City of White Rock
Hump Retaining Wall Stabilization
Marine Drive, White Rock
Contract No.: WR20 - 007

ADDENDUM NO. 1

DATE	JAN 2020	DWN:	BO
SCALE:	AS SHOWN	DSN:	CB
GEOWEST FILE:	GA17-1167-01	CHK:	DJ
DRAWING NO:	B2.01	REV:	0

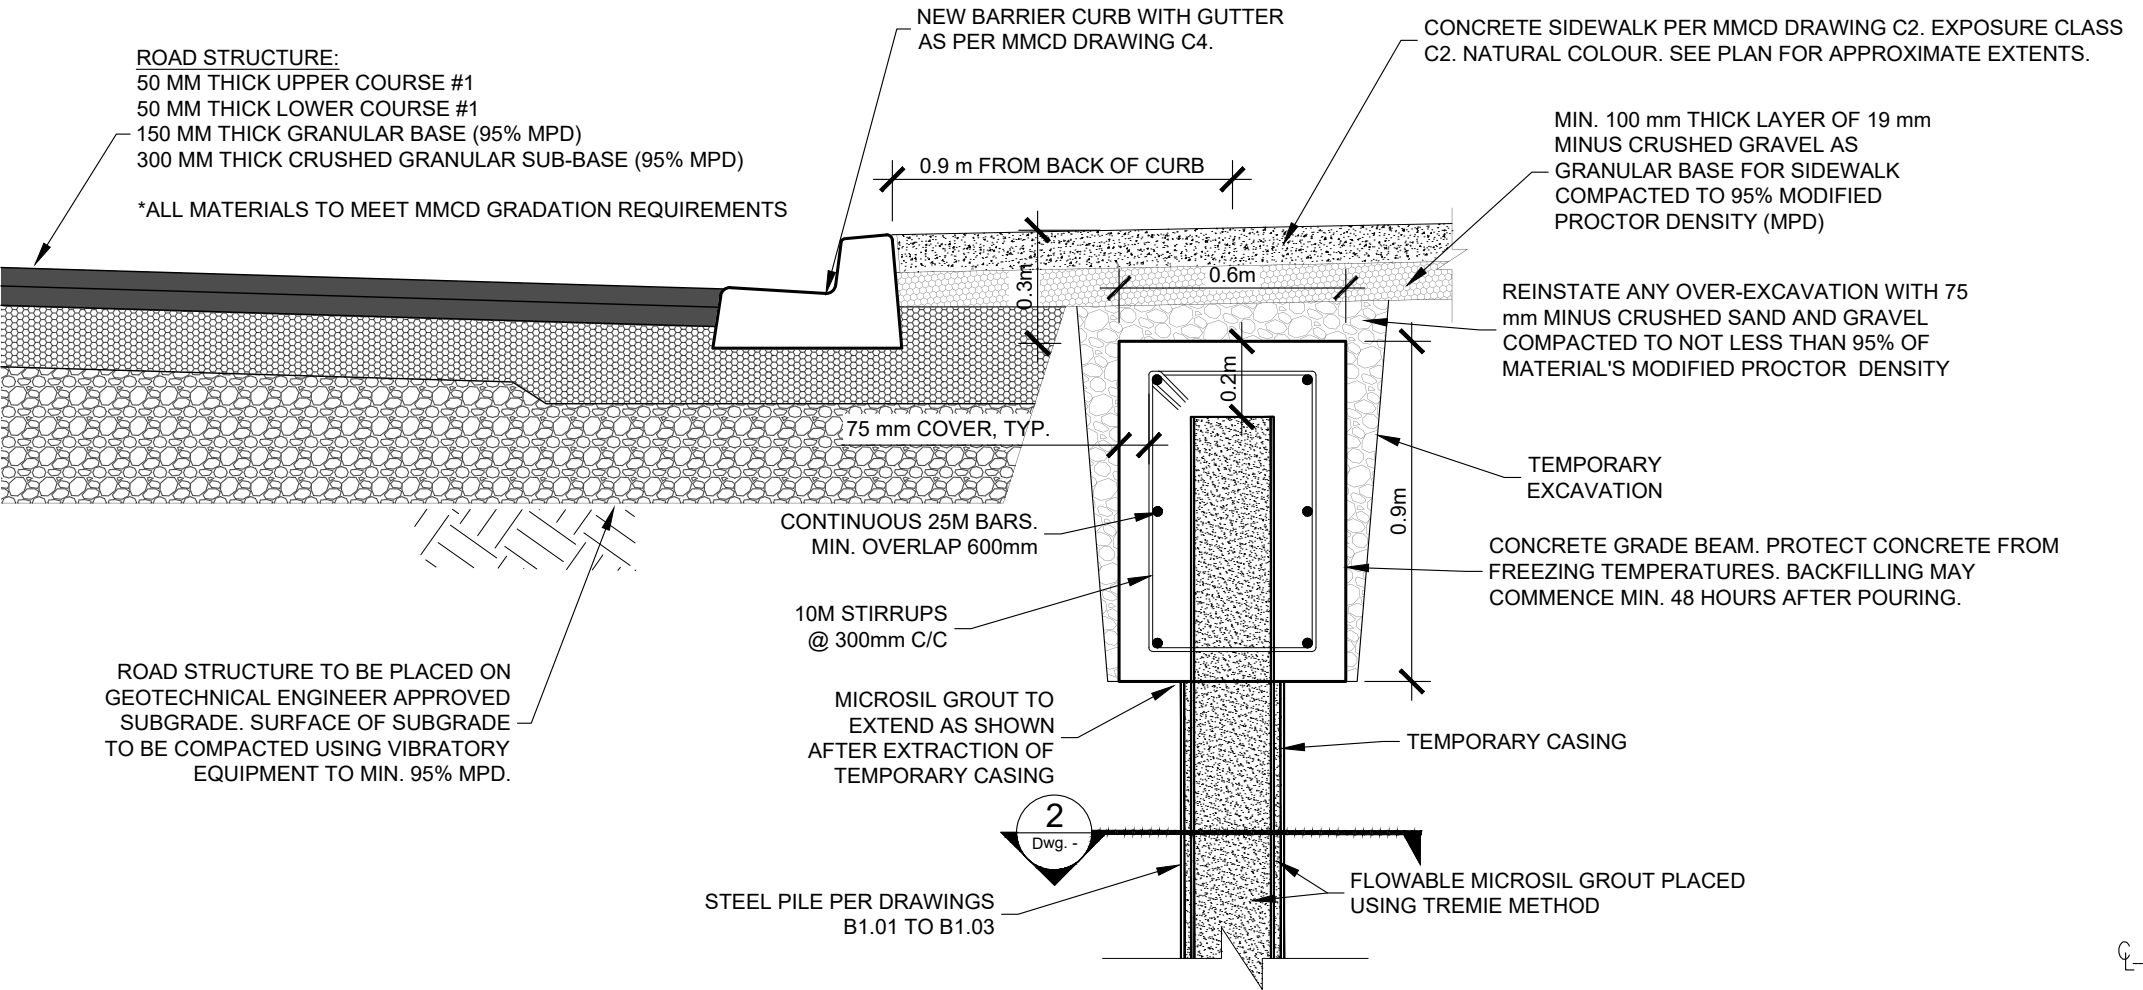
Q5: At the site meeting, it was mentioned that contractors are now being asked to expose the back of the existing bin wall. Will the unit price pay table be updated to account for the additional volumes of excavation and backfill?

Q12: SSP 14 - Interfering Services indicates " The contractor shall also, at his own expense, temporarily relocate any services which may conflict with the installation of the work." . Please provide approximate locations of existing utilities the Owner feels may interfere with the installation of the work beyond those indicated on drawing B2.01.

A5: The requirement to expose the back of the existing bin wall is referenced in Drawing B1.02 and B2.01. The estimated quantities shown on Table 1 of Schedule D include this work; therefore, no updates will be made.

A12: There is reference to "an electrical conduit that runs along the sidewalk located on the south side of Marine Drive" in the Geotechnical Assessment Report prepared by Levelton Consultants Ltd. in 2011. This conduit is not shown on information provided by BC One Call; however, there could potentially be services for lighting flowerpots. There is also a dog water fountain on the sidewalk area near the intersection of Marine Drive and Dolphin Street. Utility records for this fountain are not available. The Contractor is required to conduct utility locating at the site prior to any work.
